## SUBMITTAL TRANSMITTAL

**Submittal No: 07501-006**

PROJECT: **Harold Thompson Regional WRF**  
Birdsall Rd.  
Fountain, CO 80817  
Job No. 2908

SUBJECT: Submittal for Blower Building Wall Panels by Custom Panels

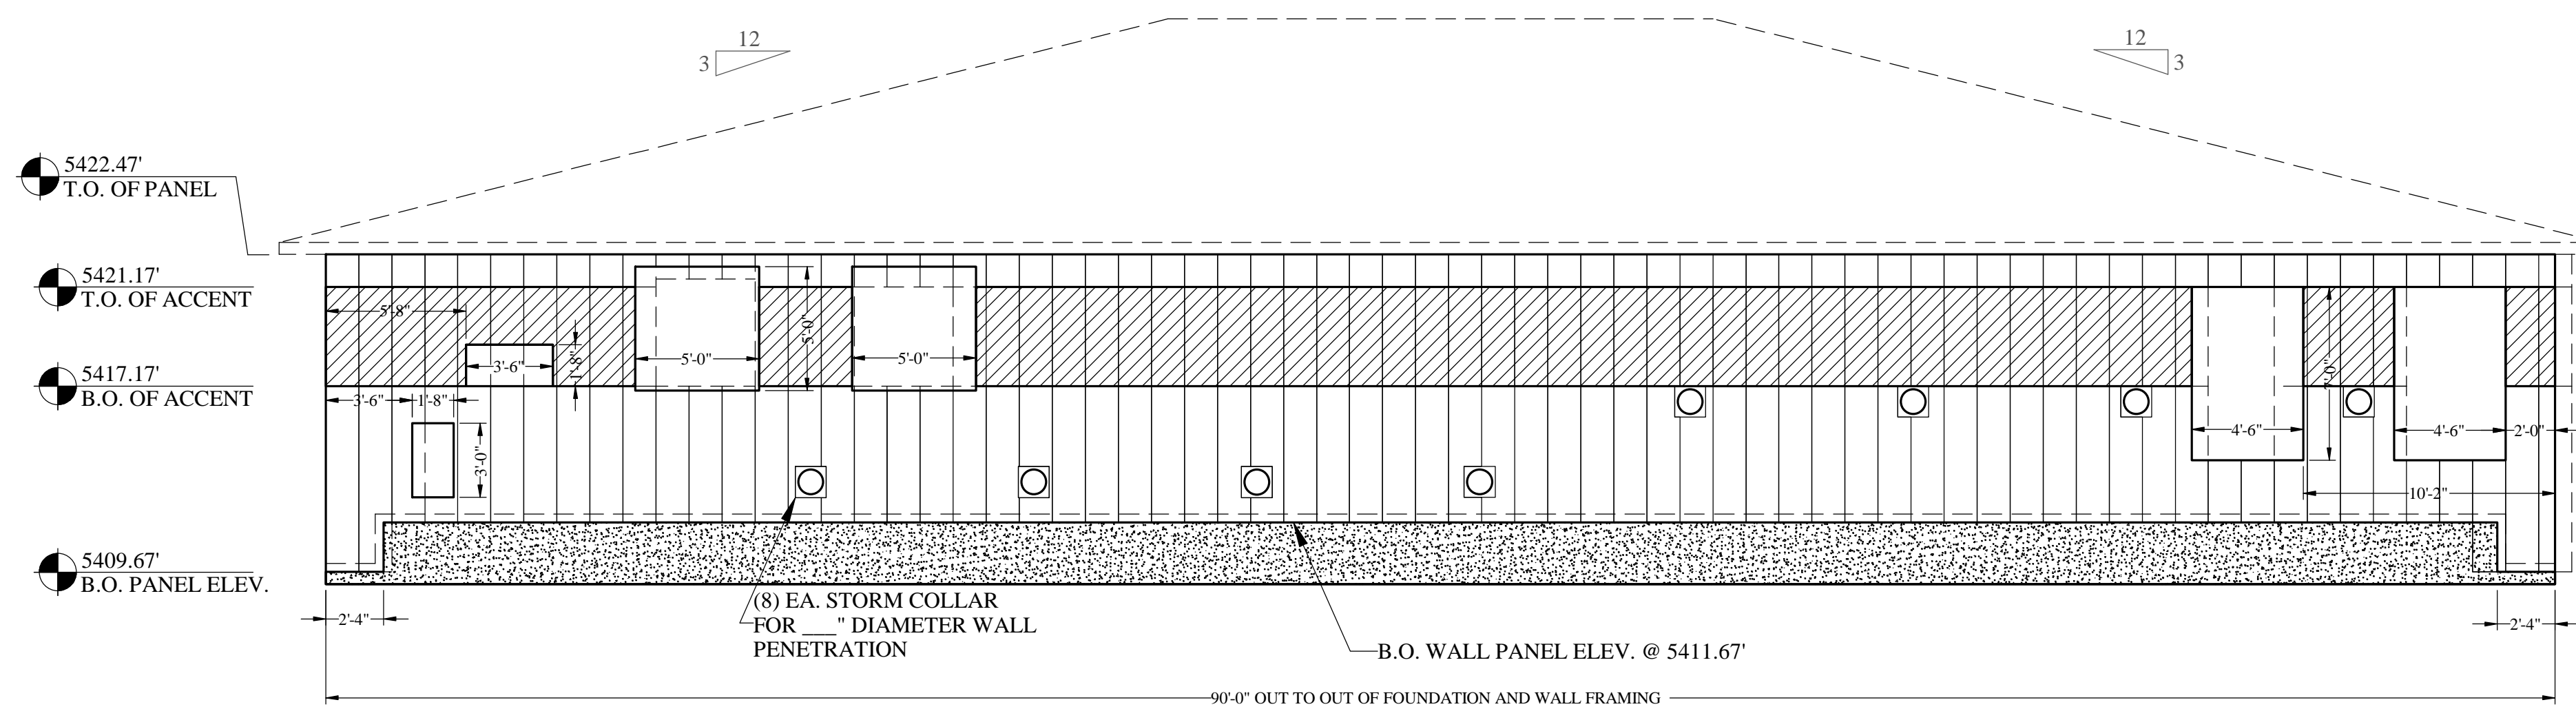
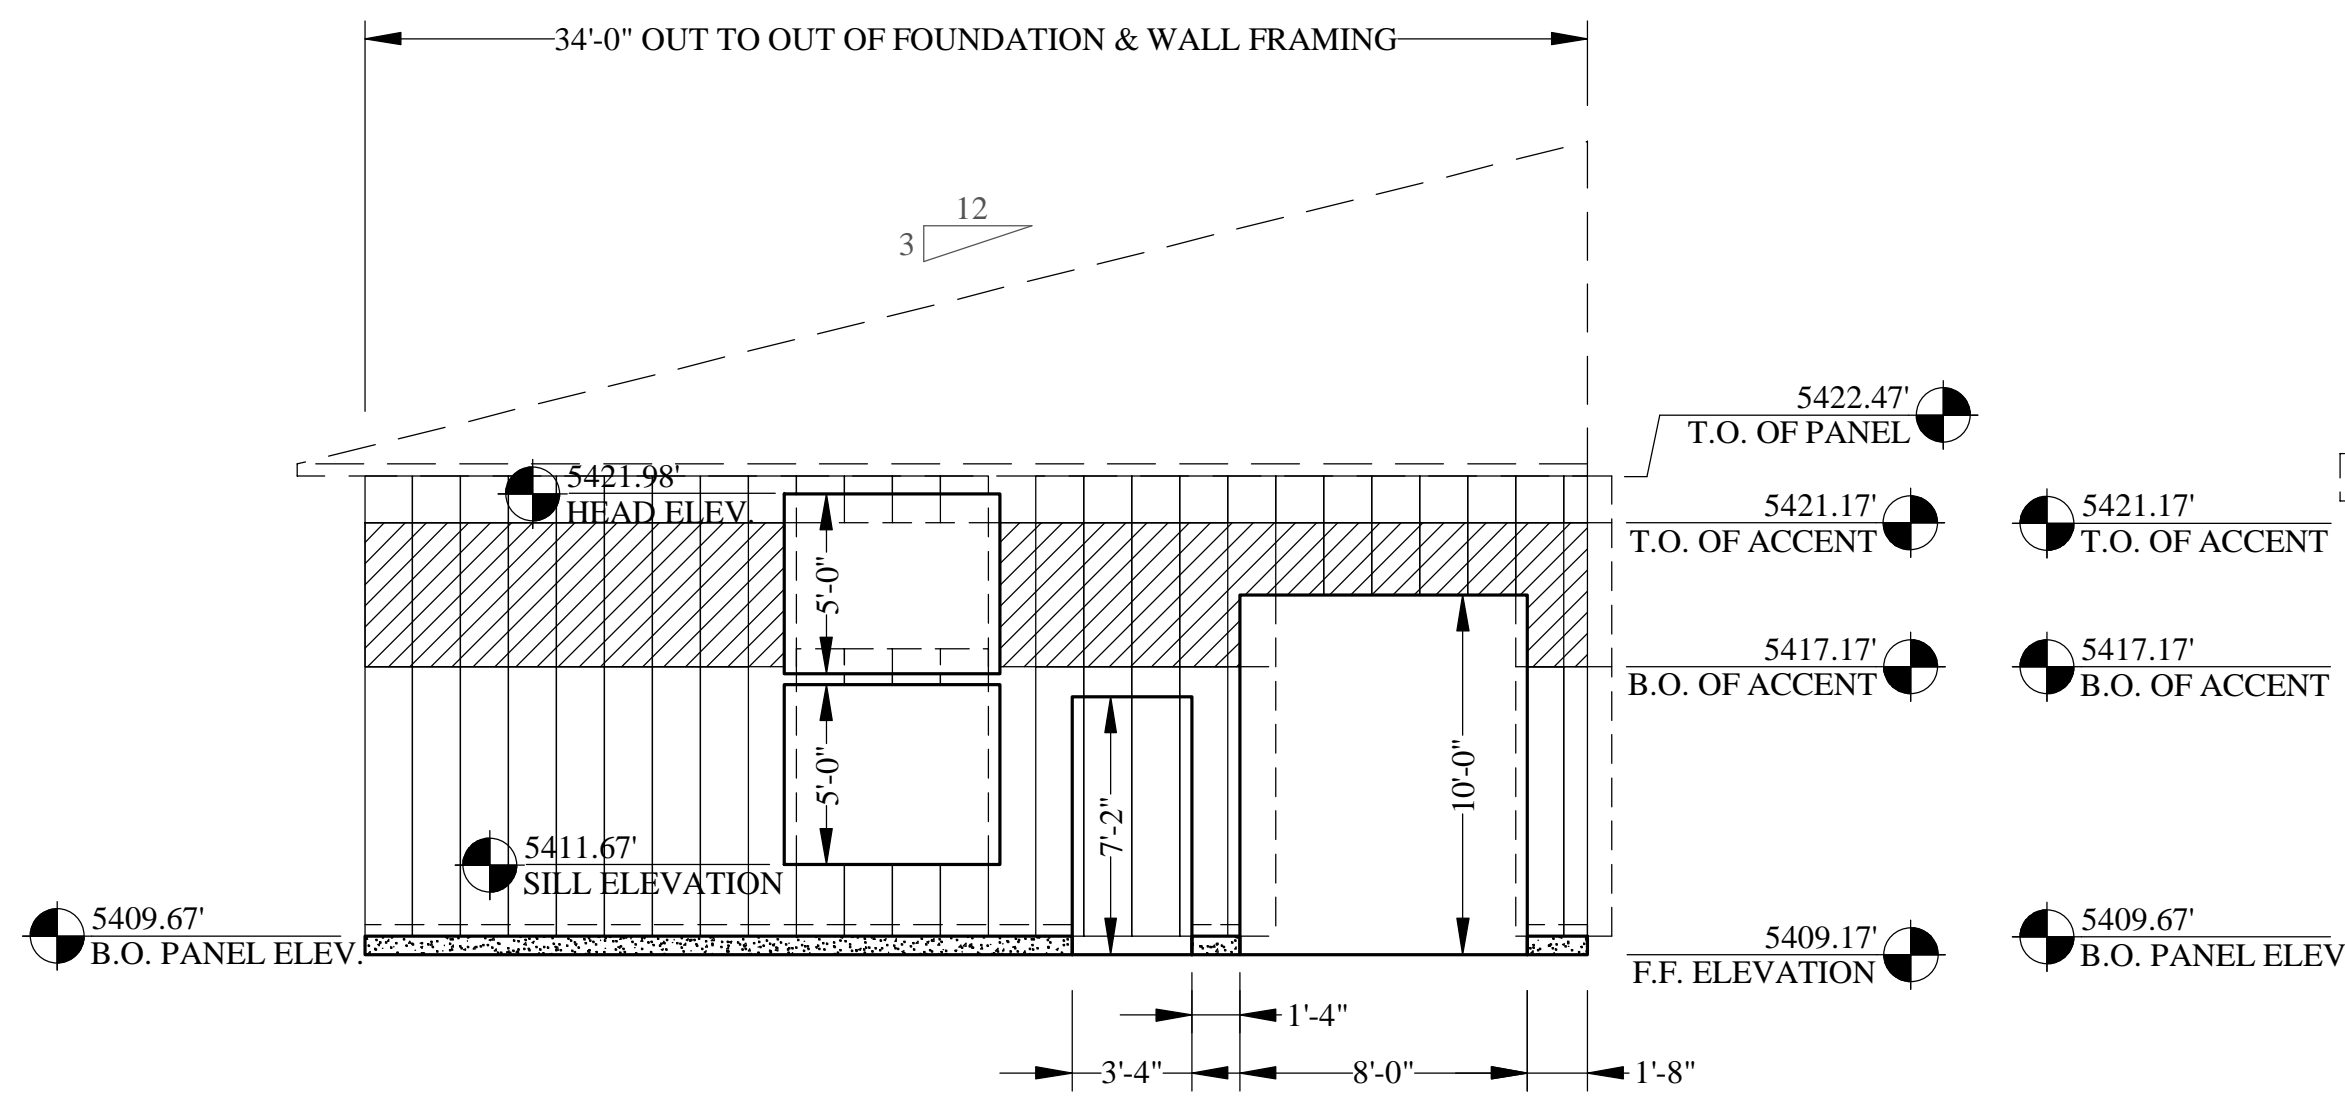
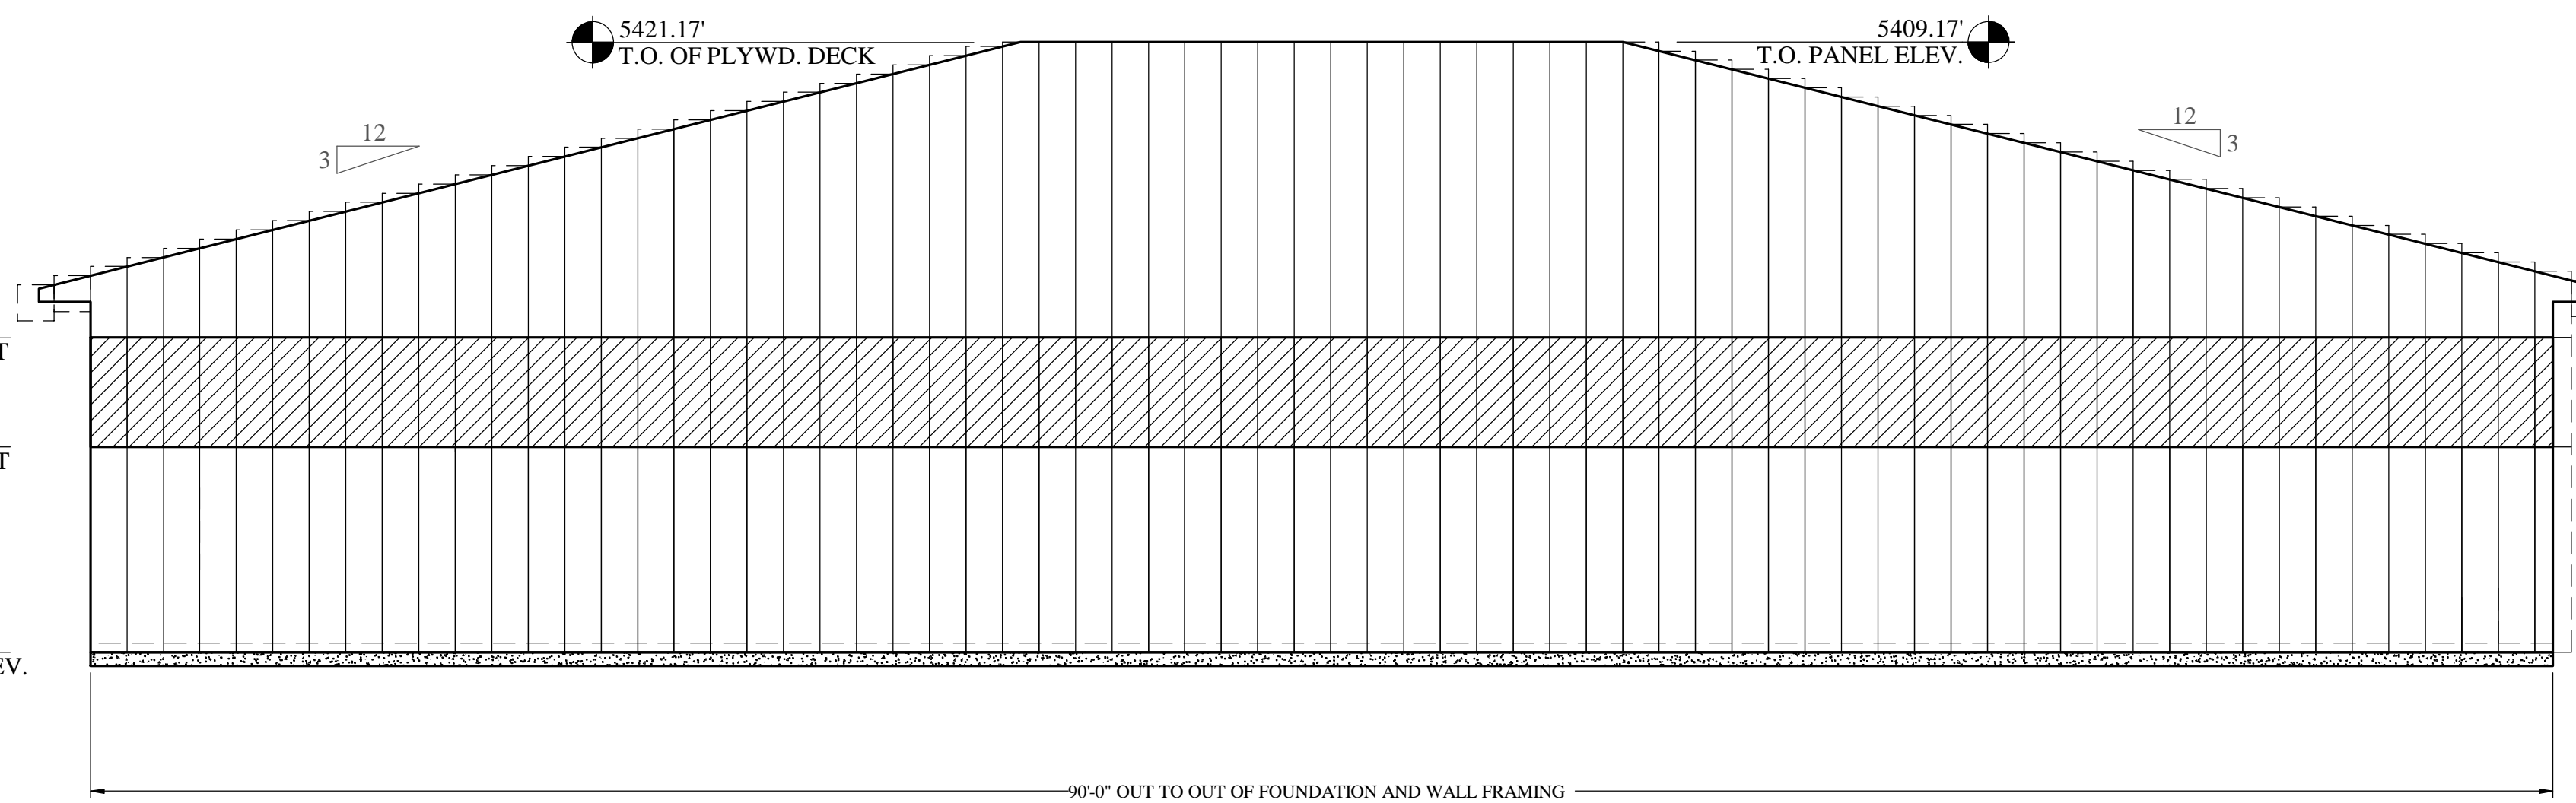
1. The wall panel openings on the construction drawings from GMS do not match the RO dimensions that we have from Kuck Mechanical. On all wall openings for the blower building we need to go with the dimensions that we have from Kuck. Kuck's submittal to follow.

EF-1 & 2 = 63-3/4" square stacked over each other, located per arch. plans (would like about 8" between fans if possible)

Louver L-1 & 2 = 72x72 net opening, stacked over each other, located per arch. plan

Louver L-3 & 4 = 54 wide x 95 tall net opening, located per arch. plans (95" tall could be a typo on the mechanical plans, 96" is more common-please confirm)

Supply register in electrical room = 42-1/4 wide x 20-1/4 tall, located 10' AFF

Return grille in electrical room = 20-1/4 wide x 36-1/4 tall, located approx 12" AFF.

2. Heath Steel has requested that GMS determine the horizontal wood framing spacing based on the attached screw specified pull-out value. The panel can span 4' and that is what we used on the metal building, but on this building the screw's pull-out value will determine the required spacing. WCM concurs with Heath's request.

- 15) Horizontal Screw Row spacing is to be determined by the Engineer of Record for this project based on the pull-out value of the fasteners attaching the metal wall panel to the wood framing. Horizontal wood framing will be required at these elevations. Please provide this spacing on the approved drawings.
